SITE PLAN APPLICATION
7025-7039 Strathmore Street DAP Narrative and Project Description

The Sketch Plan Resolution associated with the Planning Board's approval of the Sketch Plan on January 25th, 2024, includes certain conditions of approval that the subject Site Plan addresses. For the purposes of the Design Advisory Panel's review, the main comments from the September 27th, 2023 meeting minutes are summarized and outlined below, with the corresponding response from the Applicant.

DAP SUBMISSION

The Strathmore

STREETSCAPE SECTION PERSPECTIVE @ TYPICAL BAY

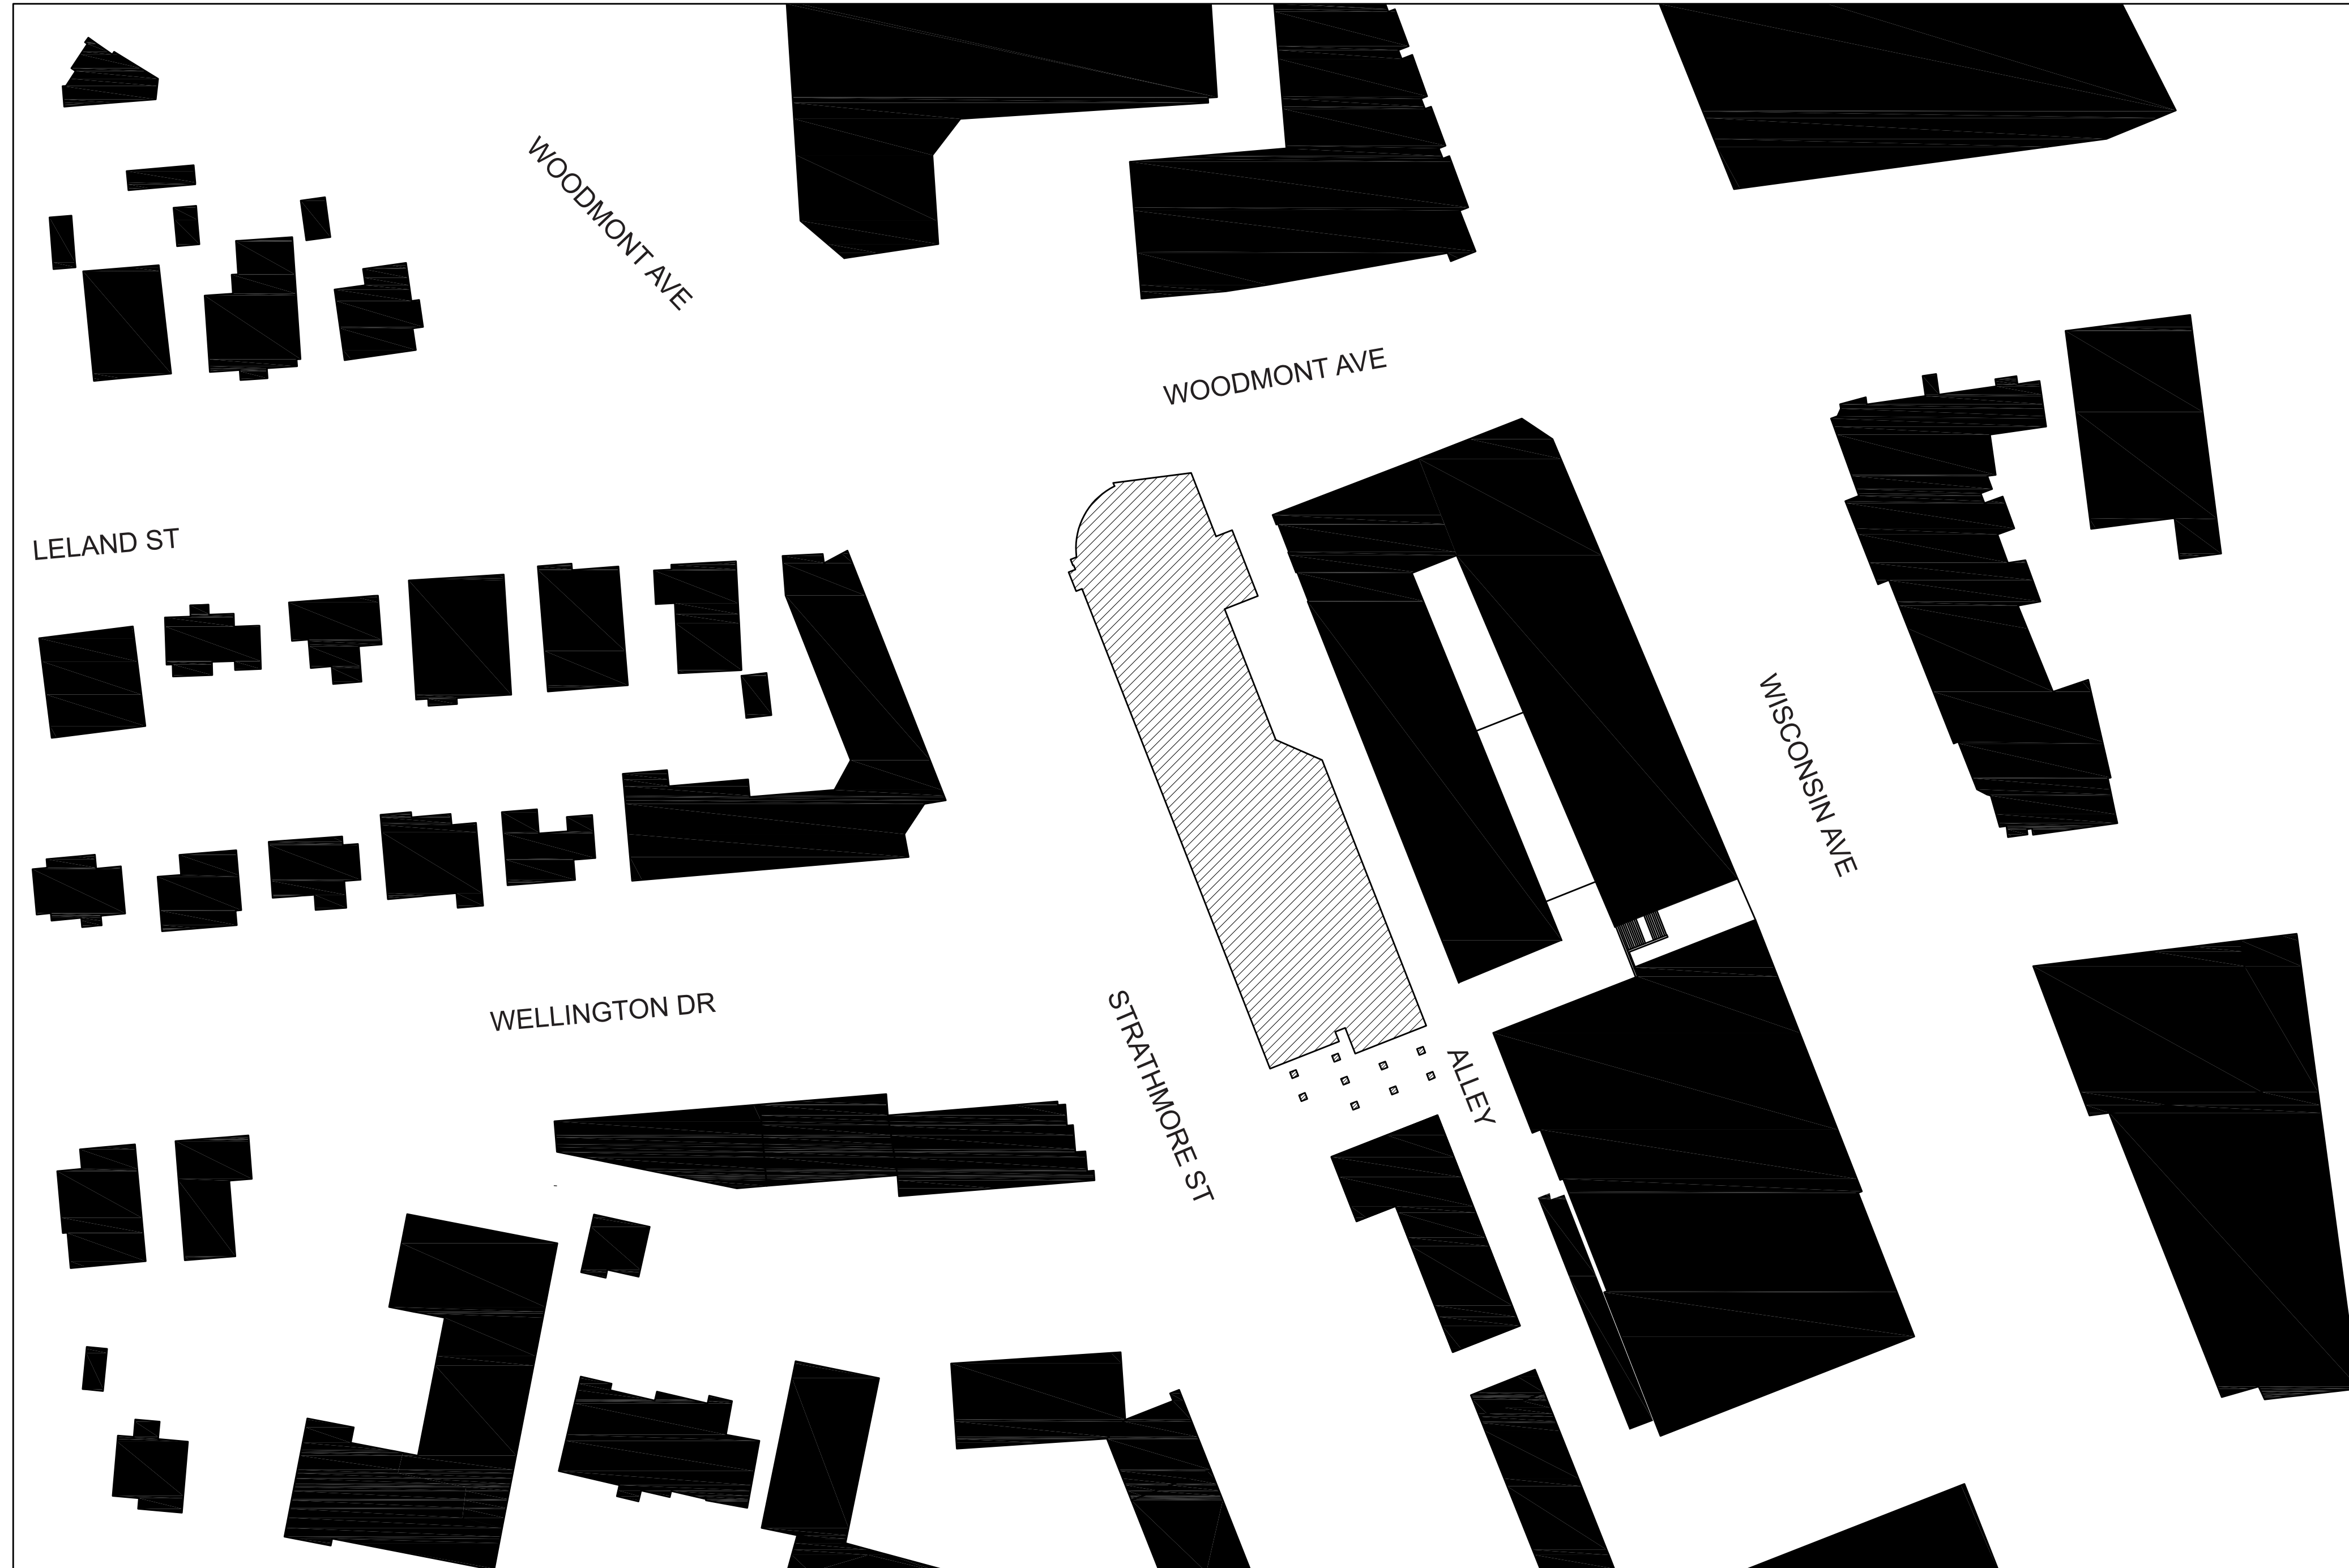
6. *Comment: It would be beneficial to have a section from the base of the curb on Strathmore Street through the building showing the ground floor and the bays above so we can fully understand how they overhang and how that effects the streetscape.*

- Response: This section has been provided to address the Design Advisory Panel's recommendation (Recommendation #2).

SECTION @ THROUGH-BLOCK CONNECTION

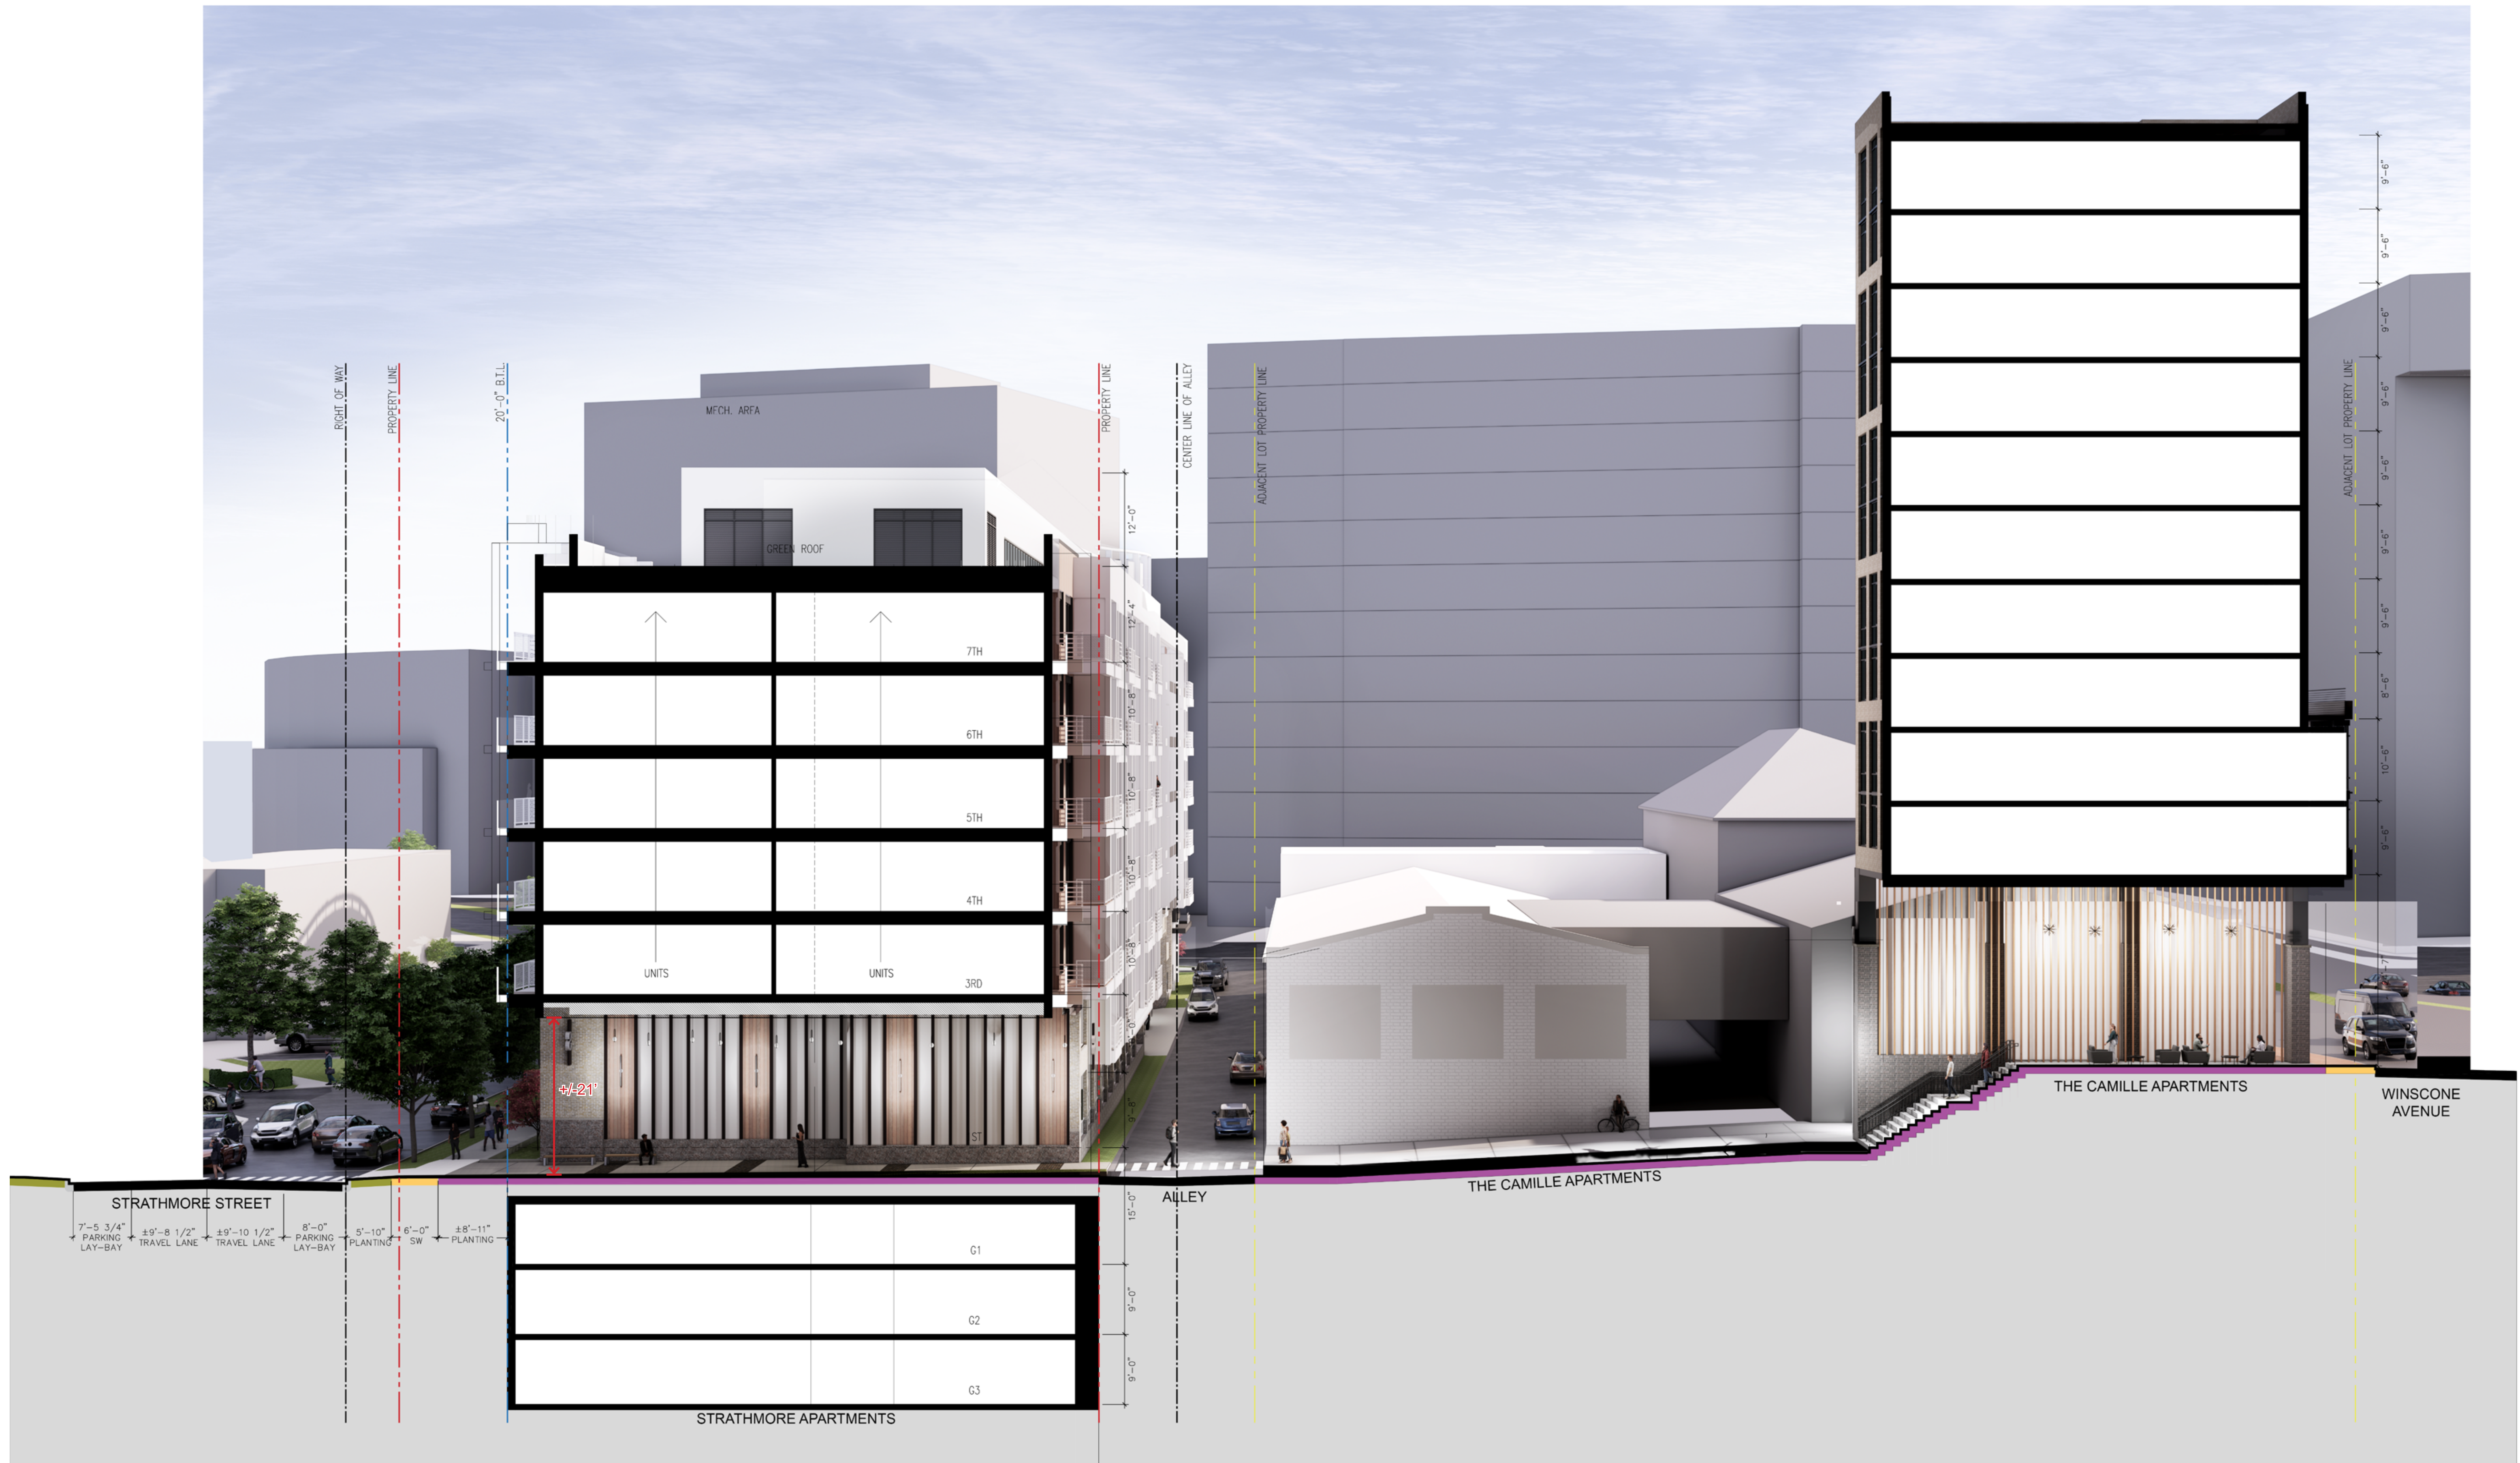
1. *Comment: What does the view corridor look like as you look through (the through-block-connection)? It would be helpful to see that. Perhaps the applicant can draw a section and Nolli type plan from Wisconsin Ave. to Strathmore St. that can help explain the procession and help clarify what is needed to maximize the public nature of this through block connection. In the partial plans and perspectives, it is not clear if the passage is inviting, open and public in presentation or character. This passage must be clearly public.*

2. *Comment: It [the through-block-connection] needs to visually read very public and I think for several reasons, one of them being the internal canopy being only one story, it compresses the space and makes it look semi-private. Having a section and seeing the whole story will inform how it can be designed more public . . . The height of the canopy within the through block connection plays an important role in that and if it is too low, it is going to cut the view from the pedestrian, maybe it could be cut into two heights?*

- Response: The procession through the cut-through has been studied and further developed. A Nolli plan, a section perspective has been provided to address the Design Advisory Panel's recommendations (Recommendation #1). Several renderings of the pass-through from different viewing points are provided. The ceiling height of the pass through has been raised, design and lighting elements have been integrated to express and embellish the public nature of the space. In doing so, more natural light will come into this space as well.

- Response: As expressed in the previous response regarding the pass-through, the canopy height and the pedestrian experience in the space has been studied further. As a result, the ceiling height within this space has been raised, a unified architectural treatment has been developed for the walls and the ceiling, lighting elements have been incorporated to make this space public, well lit at all times, and safe. The building columns within the space are rhythmically placed. Wall and ceiling details are designed to tie the space back to the passage at the Camille. The area immediately adjacent to the pass through is also developed further to include landscaping elements and a seating area and some public furniture to clearly identify this space as public.
